# Alcatraz Embarkation Site

DRB/WDAC DESIGN ADDENDUM  
JANUARY 22, 2018

BCDC Questions
WDAC Questions

## KEY

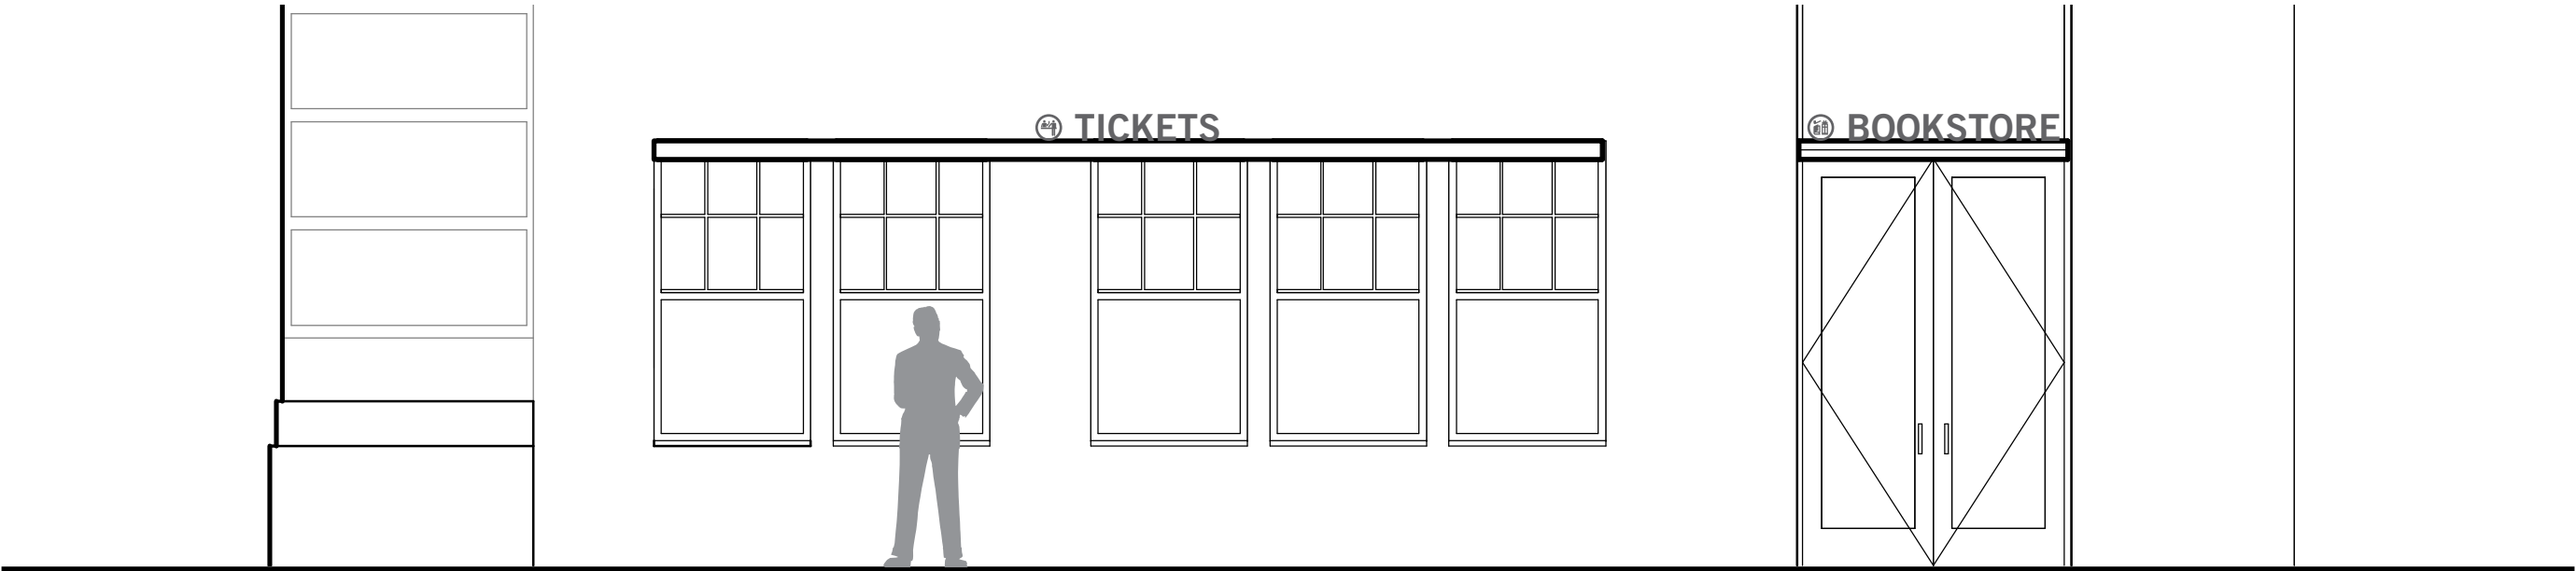
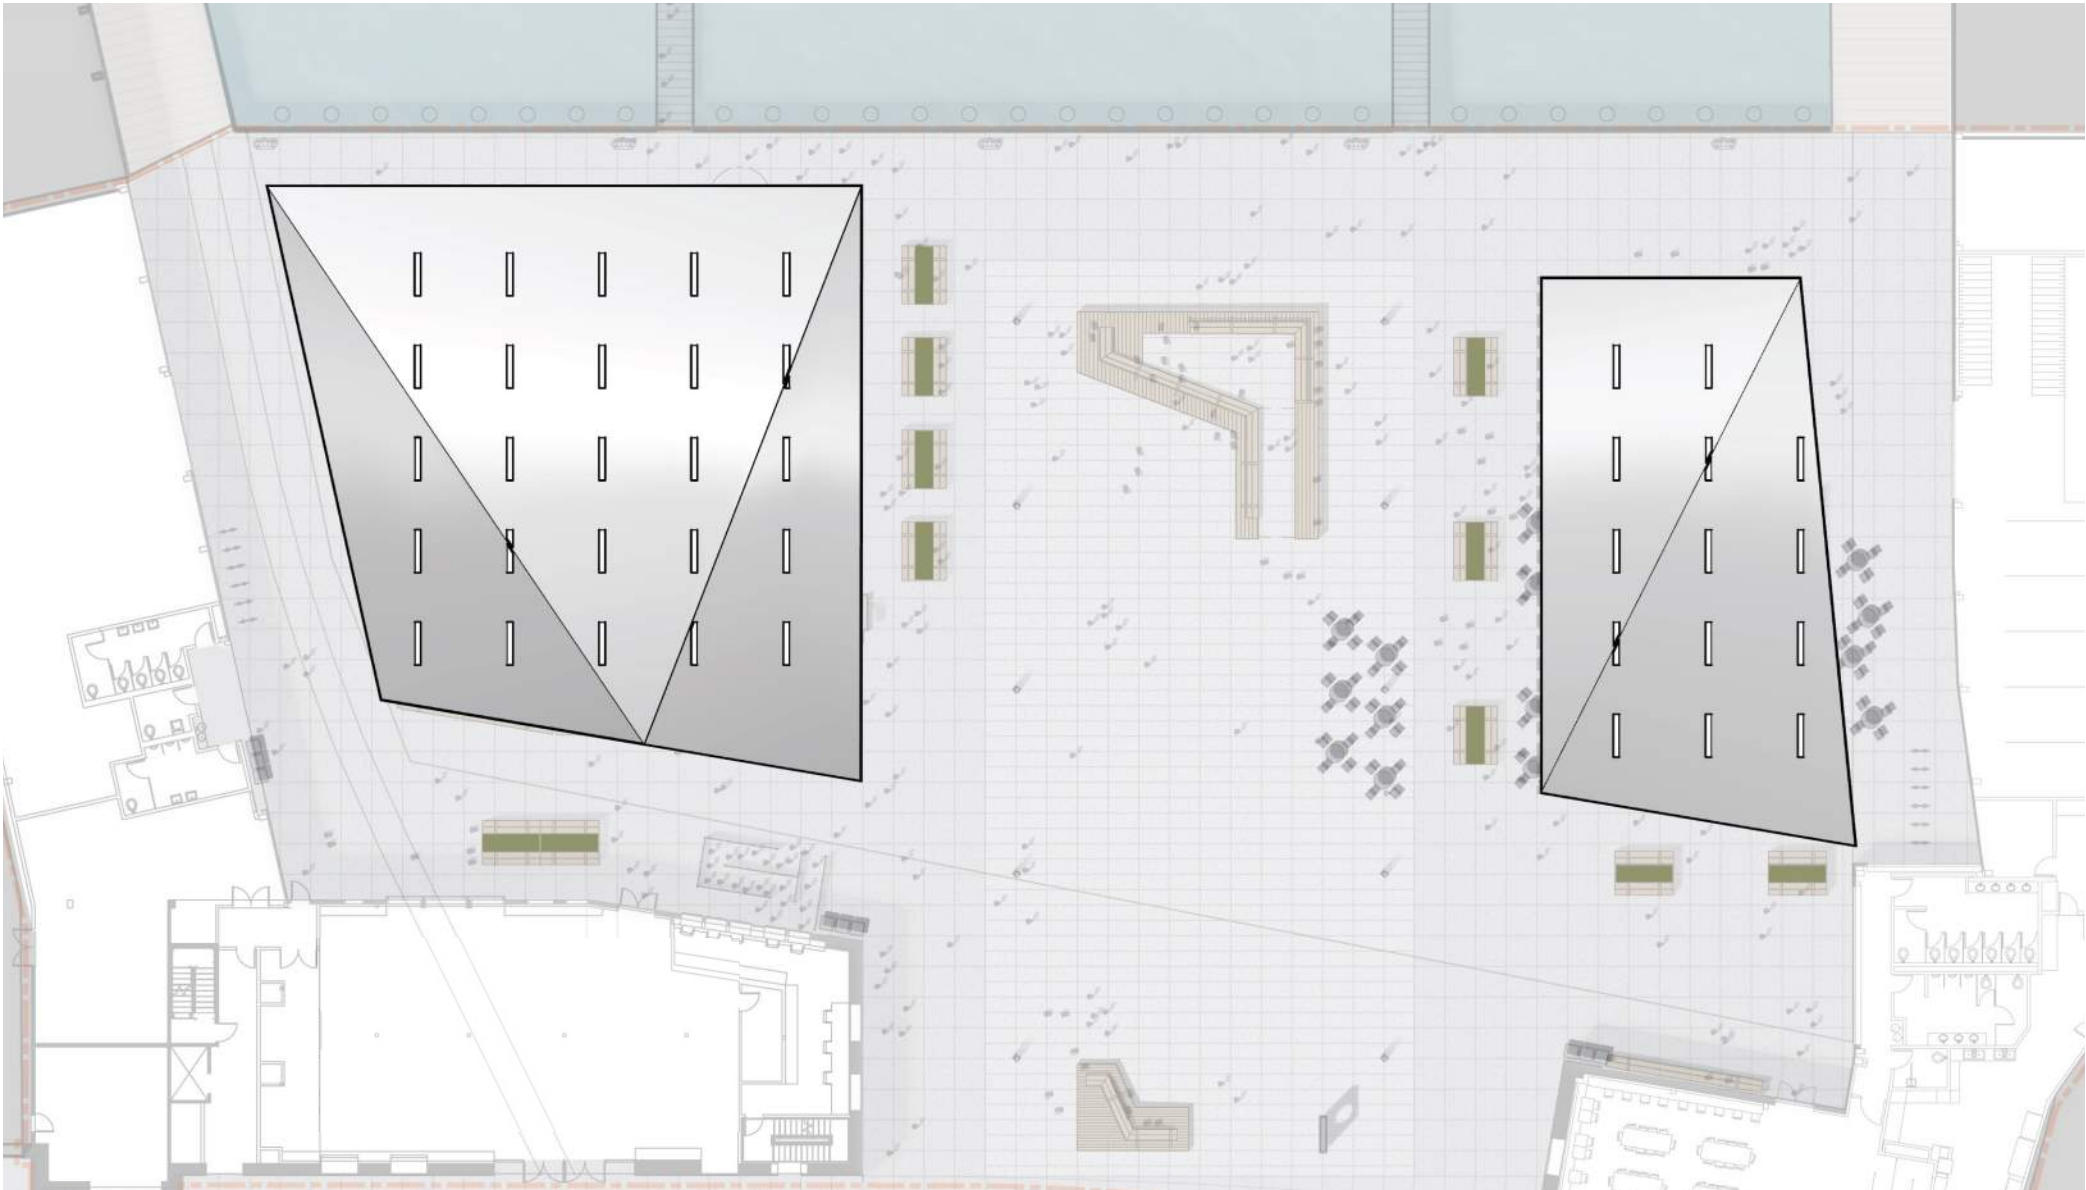
5	Although the design presents a strong sense of arrival for visitors, the wayfinding does not appear adequate. People may need more identity to the purpose of the site. Please put more thought into signage and wayfinding including directing people to the ticket booth.	9, 10	
6	Increase the number of bicycle parking spaces, perhaps including some in the open space, or more directly connected to the plaza.	26	
6	Concern that access to the bike parking will not be understood.	9, 26	
7	Include additional seating in the central zone.	26	
7	Concern that the interpretation will not feel accessible to children and foreign visitors.	6, 7	
8	Include things for children to do while waiting for the ferry, expand the ways the interpretive amenities can be experience, beyond the proposed panels.	6, 7	
8	Concern over the void of planting. May want to use planting to make the space feel less civic and more tied to Alcatraz.	27

9	Improve the signage and wayfinding to easily direct the public to the location from the outside of the site and to the ticket booth once they arrive.	9, 10	
9	Appreciated the consistency of aesthetic in roof forms and furnishings.		
10	The NPS icon is obscure. Enhance the signage but incorporate it in a way that does not detract from the architecture.	10	
10	Roof forms are successful with the pier sheds, views and materials of Alcatraz.		
11	Include plantings to begin the story and set up a distinct experience as the gateway to Alcatraz - something that will tie thematically to make it richer and layered as opposed to the current civic waiting zone.	27	
11	Would like to see views of the project from the water.	16	
12	Share more with the joint Board about what is envisioned as part of the interpretive story in addition to the panels.	6, 7	
12	Suspect of the "bar" seating as it feels forced. Consider two-sided seating.	25

Visitors require conspicuous, clear and immediate wayfinding information for their time-sensitive visit to the site.

A monument sign stands proud at the entrance, at a scale that matches the surrounding buildings and is visible for both pedestrian and vehicular traffic.

Wayfinding signs adorn the interior corners of the bulkhead building to quickly direct visitors to the primary destinations of interest.

Primary destinations, including boat queues, tickets, information, restrooms, bikes, cafe and bookstore are all prominently marked with a consistent signage style.

Primary and secondary boat queues are marked accordingly. Each is augmented with an A/V (LED) display to show (changeable) intended use and up-to-date departure information. These devices may also display interpretive information/imagery. A "trailhead" graphic adjacent Queue 2 allows visitors to learn about other GGNRA destinations, as well as nearby transit options (shown as item 7 in the interpretive exhibit family).

queue 1 canopy

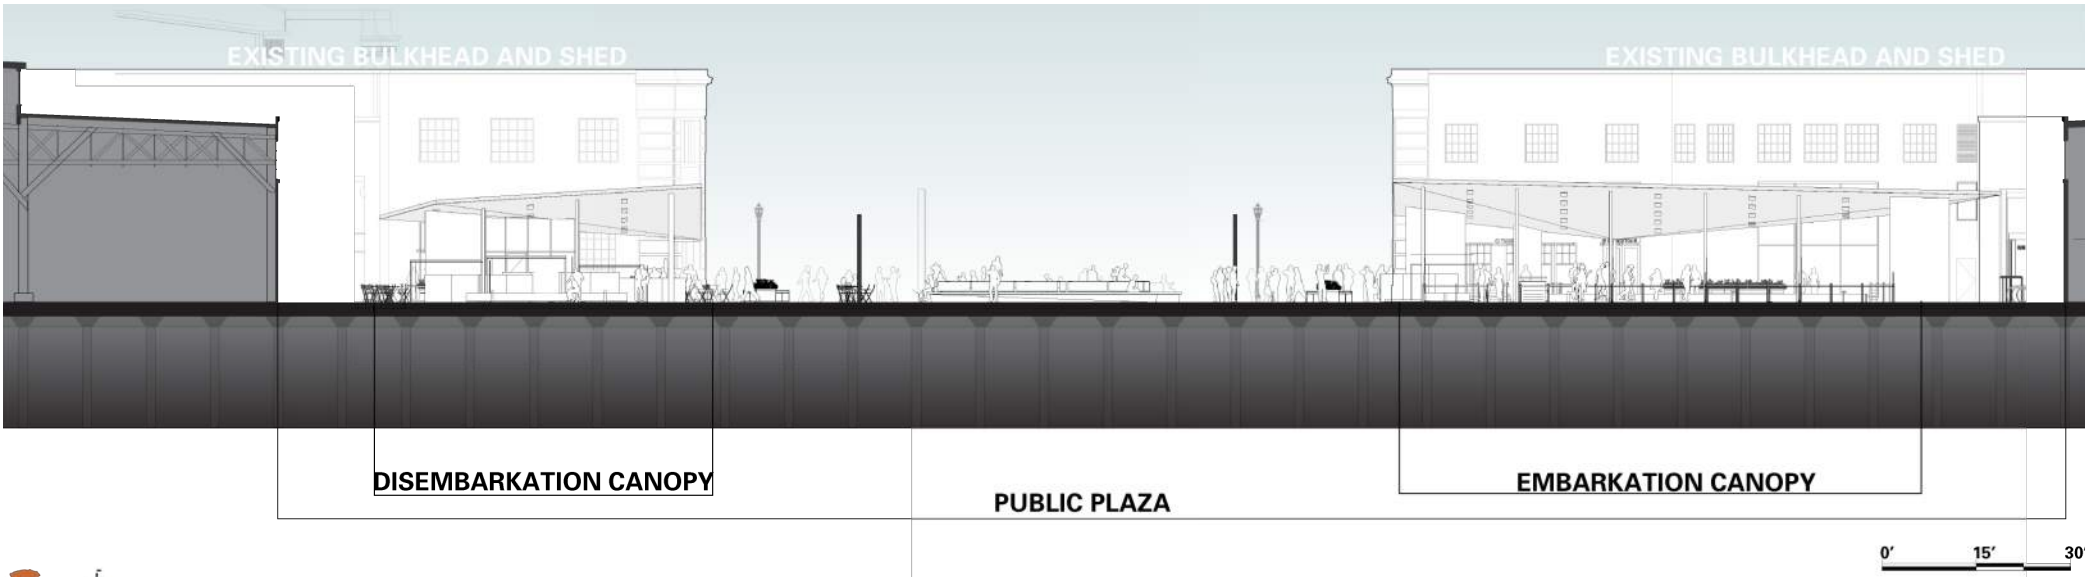
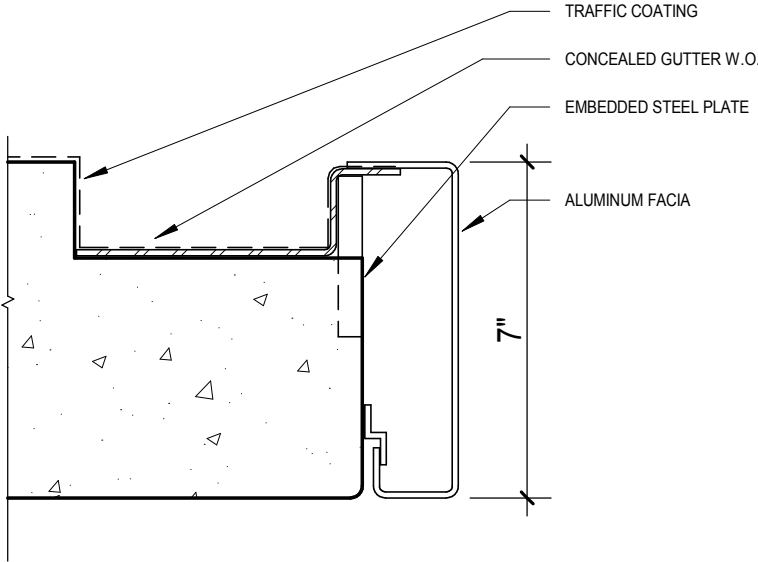
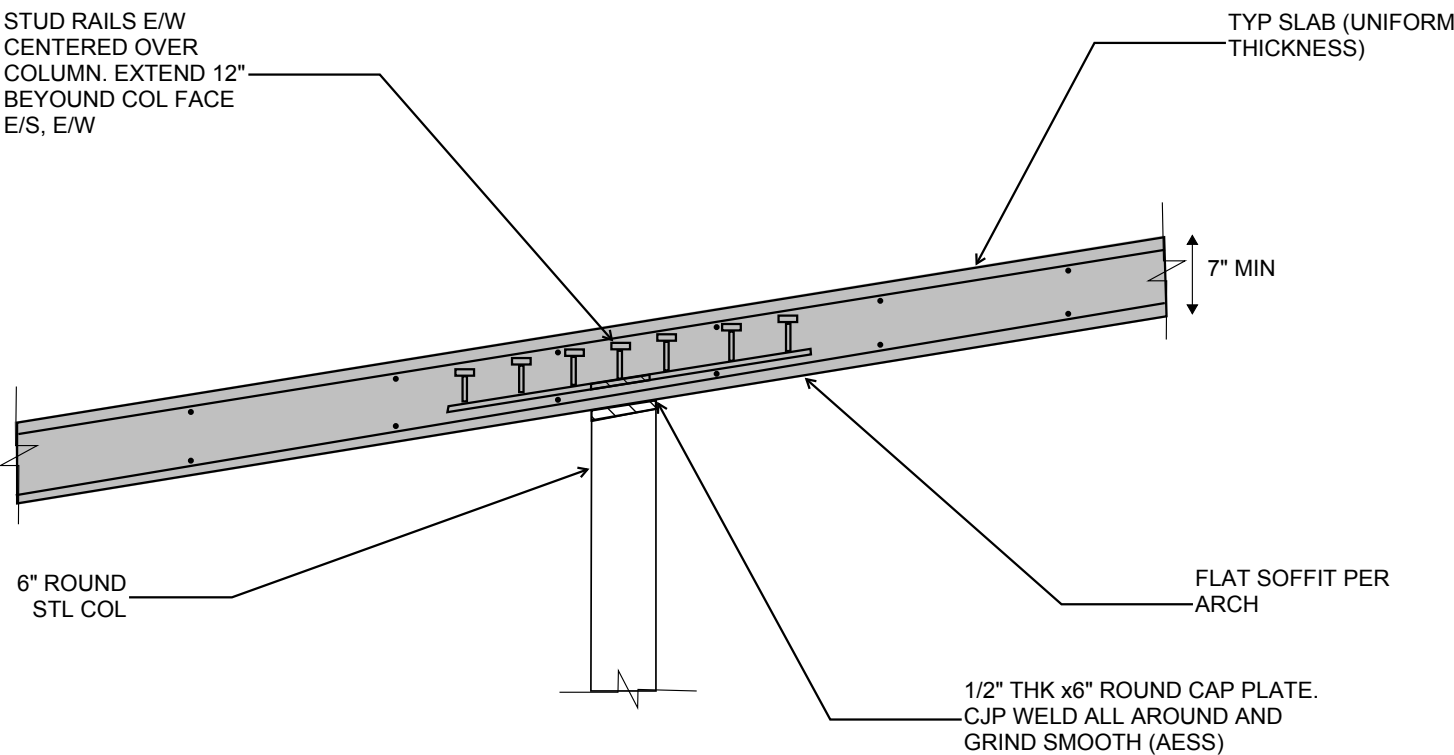
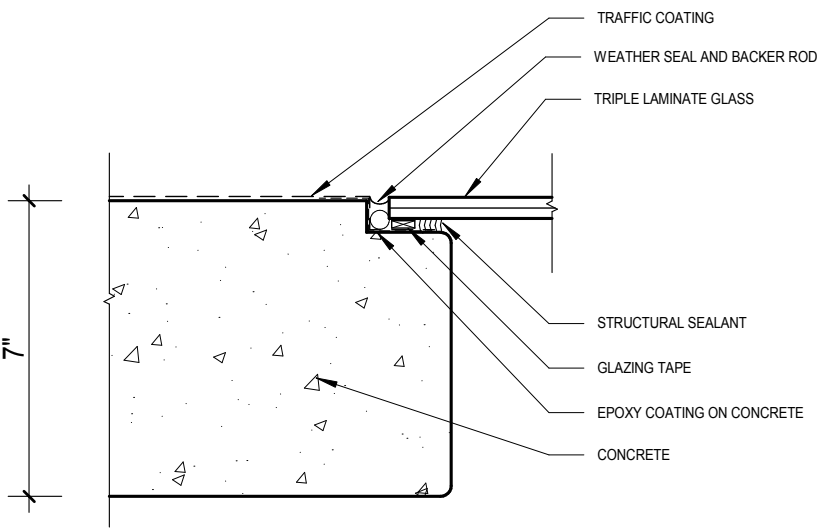
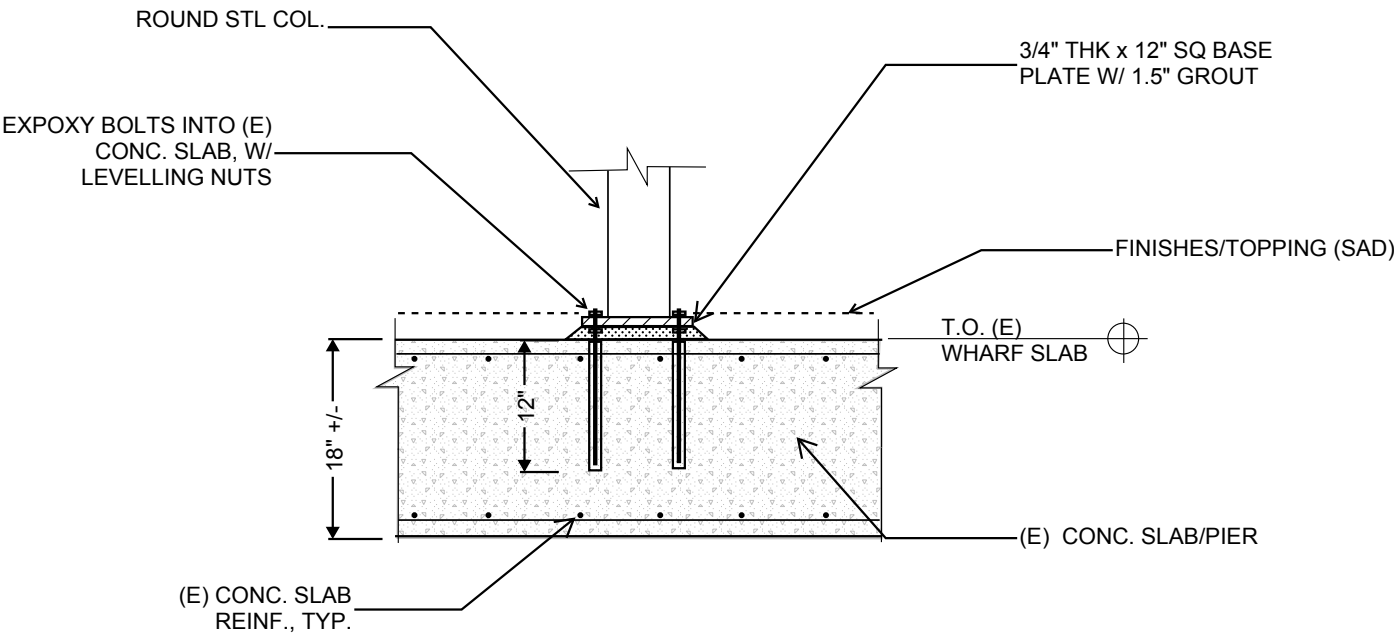
COMMENT #	COMMENT	REFERENCE PAGE	NOTE
1	Design the removable bollards lower and wider to resemble furniture.	21	
1	Bollards at the street are an important element and may need further consideration of their detailing.	21	
2	Ensure that the concrete canopies and connections down to the pier maintain the elegance as depicted in the drawings.	17	
2	Concrete canopies look good as designed, hoping that shown elegance is maintained into construction.	17	
3	Ensure that the railing is not mistaken as seating, that it cannot be climbed upon given the raised curb at the base.	28	
3	Railing looks like a seat and may be climbable, please review.	28	
4	Consider night waterfront viewing when developing the lighting design.	18	
4	Is there a lighting plan? (CMG presented the concepts)	18	
5	The buildings along the Embarcadero orient to the tangent of the roadway. Consider a different geometry than imposing a rectangle in the middle, such as a fan shape that is more appropriate to the context and which would allow a more open interpretation of the view. The parti is appreciated, but a consideration of the plaza shape would be appreciated.	24	Narrative

13	Include views of the project from the water in future presentations to the joint Board.	16	
13	Want the slots in the roof system to function as skylights letting light in and exposing shadow. These could make the spaces below "magical".	17	
14	Consider changing the bar seating at the raft to two-sided benches that can be used as bar seating and for viewing and events.	25	
14	Signage appears to be too minimal.	9	
15	Incorporate as much differentiation as can be achieved by using like materials between Herb Caen Way and the "carpet" to invite the public in.	24	
15	Concerned about the "rock" icon. May not be understood and appear odd. Appropriateness of only placing one rock on the site.		Narrative
16	Consider the central part of waterfront railing as a different experience, different design.	28	
16	Would not like to see signage added to the other site elements.	9	
17	The same design experience of the plaza should carry through to the in-water connections to the ferries.		Narrative

The east canopy has been reduced in size to avoid the joint where the Marginal Wharf and Infill Wharf meet. While responding to site specific constraints, the canopy roof forms are designed to welcome and guide visitors as they embark and disembark from Alcatraz.

To achieve a minimal thickness of 7" throughout the canopy, post tensioning and optimal column spacing were used. The canopies have linear skylight openings to create a space that feels open and well balanced with natural light.
